"Maria Rickmers."  
 Greenock Report No. 10457.

Pumping Arrangement  
 R. & W. 267  
 Scale 3 inch = one foot.

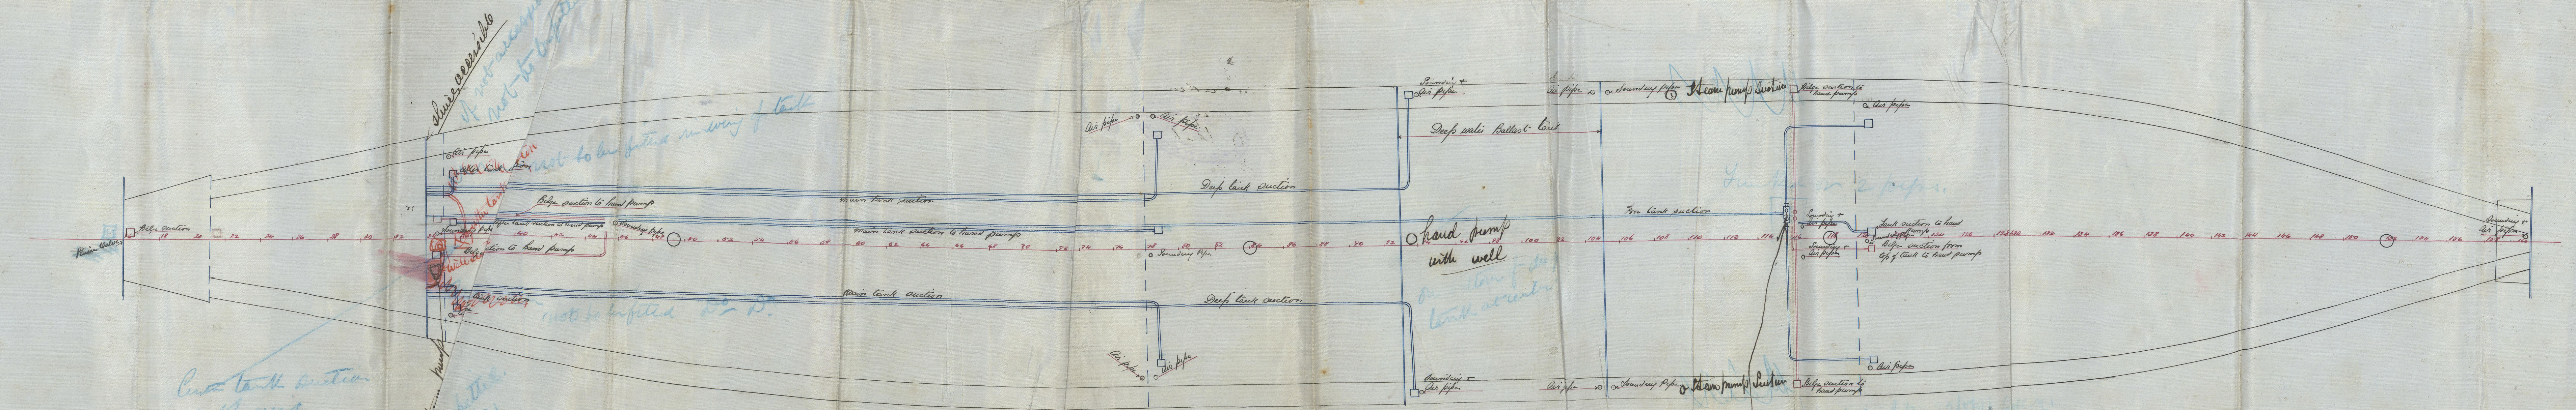
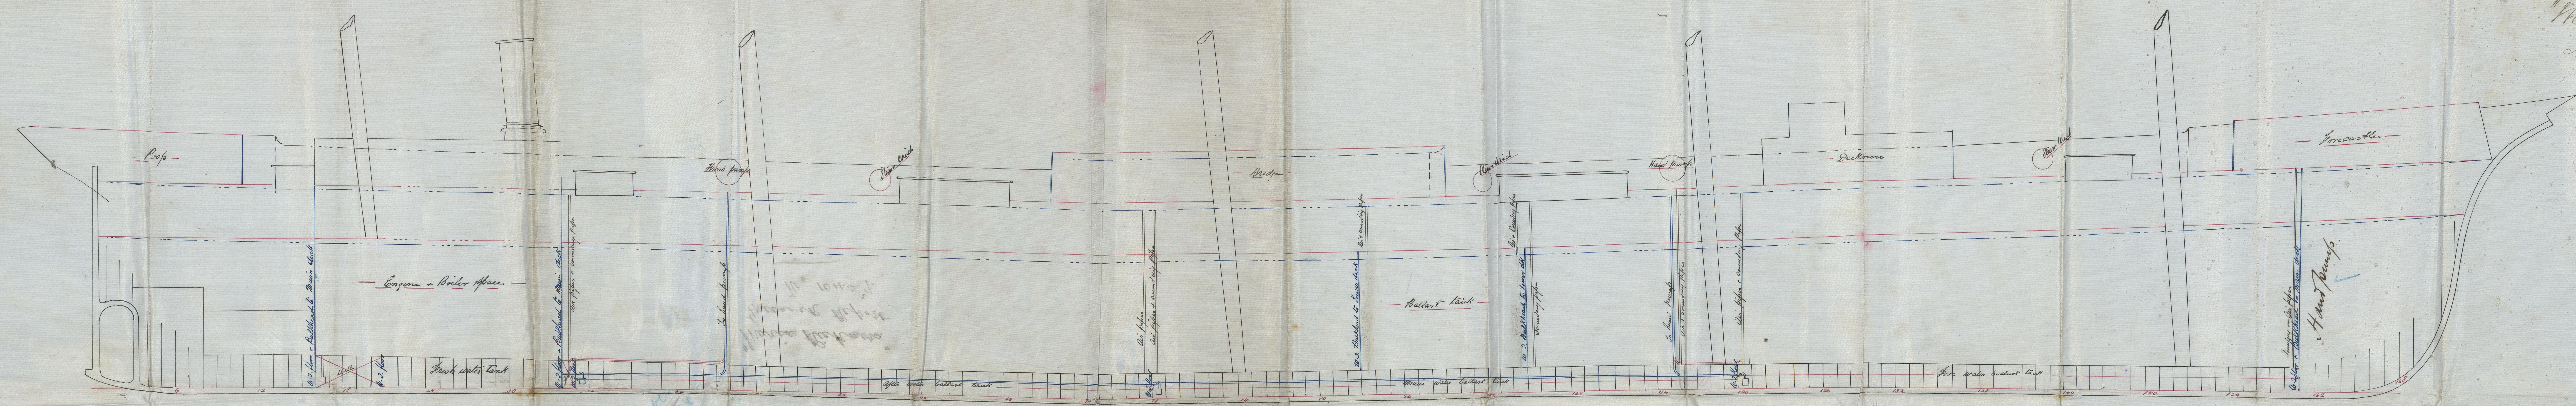
Cross tank section  
 sufficient.

Air pipes  
 not to be put in wing of tank  
 not to be put in tank

not to be put in tank

These valves to be always available
